APPLICATION NO.	FILING DATE	FIRST NAMED INVENTOR	ATTORNEY DOCKET NO.	CONFIRMATION NO.
10/085,493	02/27/2002	Jacquelin A. Vantroostenberghe	Male Urinary System	4926
7590 12/17/2003			EXAMINER	
DAVID G. HENRY 900 Washington Avenue P.O. Box 1470 Waco, TX 76701			BOGART, MICHAEL G	
			ART UNIT	PAPER NUMBER
			3761	/D

Office Action Summary

VANTROOSTENBERGHE,
JACQUELIN A.

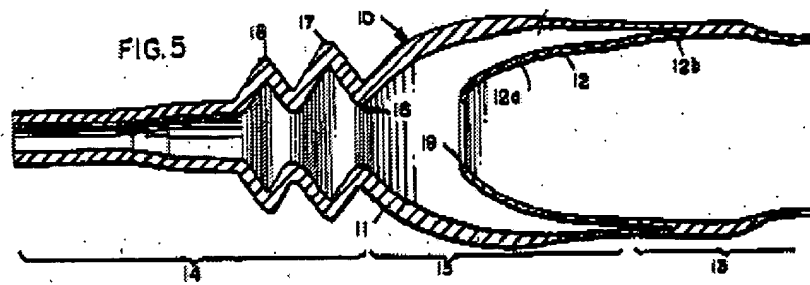
Claim 1 is rejected under 35 U.S.C. § 103(a) as being unpatentable over
Schneider (US 4,626,250).

penis/urinary collection interface unit (10), said penis/urinary collection interface unit (10) a primary receiver unit (12) for accommodating at least a portion of the length of a male penis during urination, and a secondary containment unit (15) in which said primary receiver unit (12) is at least partially nested with proximal margins (12b) of said secondary containment unit (15) and primary receiver (12) unit being fused to prevent fluid ingress or egress past the line of juxtaposition (12b), said primary receiver unit (12) being positioned relative to said secondary containment unit (15) whereby a gap (20) is formed between the outer surface of said primary receiver unit (12) and the inner surface of said secondary receiver unit (15), said gap (20) extending at least from the distal end (12a) of said primary receiver unit (12) and the said line of juxtaposition (12b) between said secondary containment unit (15) and said primary receiver unit (12), said primary receiver unit (12) opening (19) at its distal end (12b) into said secondary containment unit (15) near the distal end (16) of said secondary containment unit (15);

conduit means (14) attached to said distal end (16) of said secondary containment unit (15) for collecting urine flowing from said distal end (12b) of said primary receiving unit (12)(see Fig. 5, below).

Schneider therefore expressly teaches every element of the claimed invention except for a urine receptacle.

The device taught by Schneider is clearly designed to be emptied into something. Similar devices in the art provide receptacles to collect urine, as discussed by the reference (col. 1, line 61). At the time of the invention, it would have been obvious to one of ordinary skill in the art to provide a suitable receptacle with the device as taught by Schneider in order to provide a means of collecting urine expelled from the device.
